TENNESSEE VALLEY AUTHORITY

Enclosed for NRC review is information concerning material and geometric damping at Watts Bar Nuclear Plant. This information should resolve open item 9 of the draft Safety Analysis Report.

WATTS BAR NUCLEAR PLANT UNITS 1 AND 2
MATERIAL AND GEOMETRIC DAMPING

FIGURE 1 Schematic of Lumped Mass Model Analysis

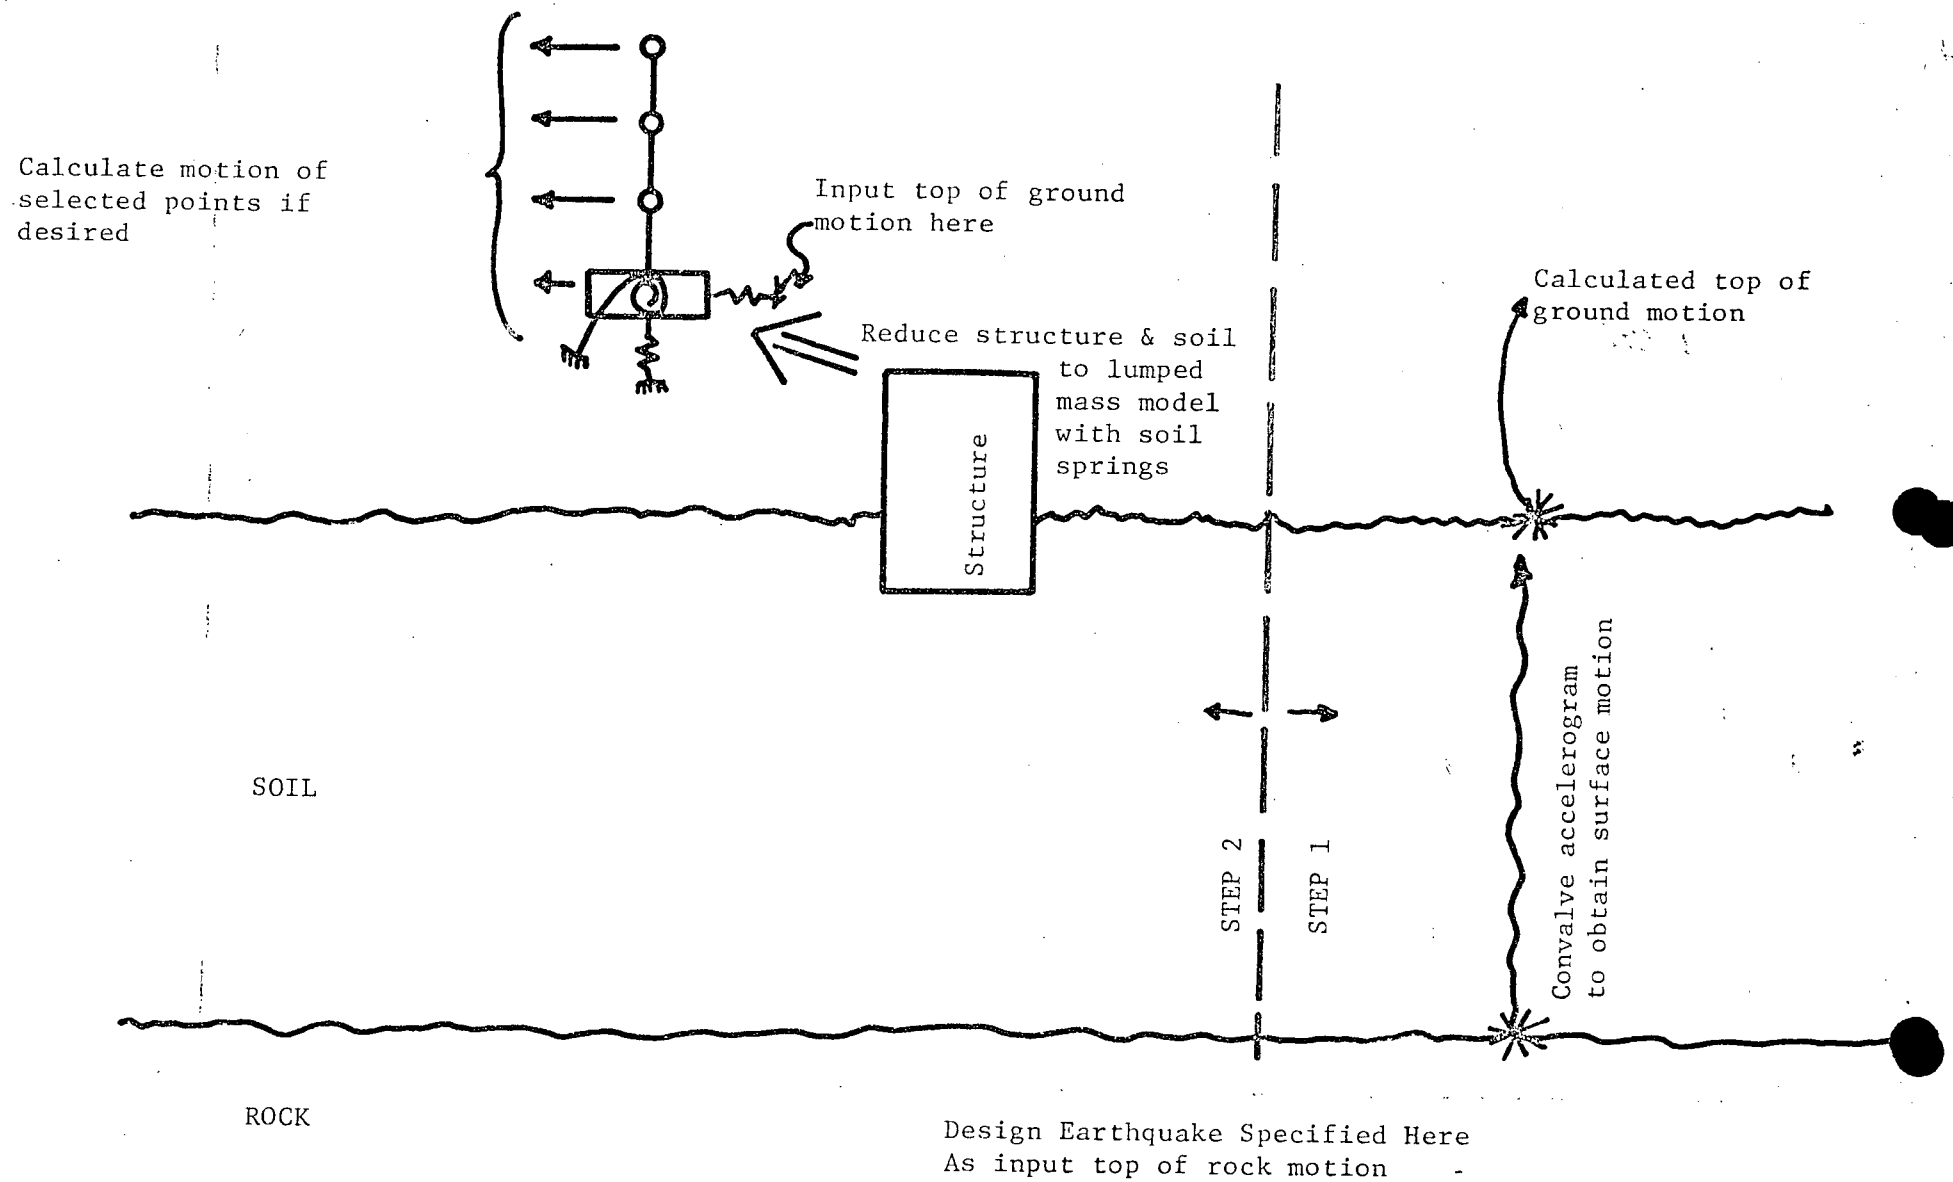
In response to Question 362.33 the applicant has indicated that for the seismic analyses a soil damping ratio of 10 percent was used for the soil deposit underneath the structures and the primary motion was translatory rigid body motion. The staff requires that applicant must provide values of the material damping and geometric damping used in the SSI analysis in the various modes of vibration of the foundation of structures for the OBE and SSE conditions.

In the lumped mass modal analysis method, soil damping is incorporated in two stages. First, the top of ground acceleration time history is determined by amplifying the top of rock acceleration time history through the soil. Second, the response of the lumped mass modal representing the structure and soil is determined. This procedure is described briefly as follows and shown schematically in figure 1.
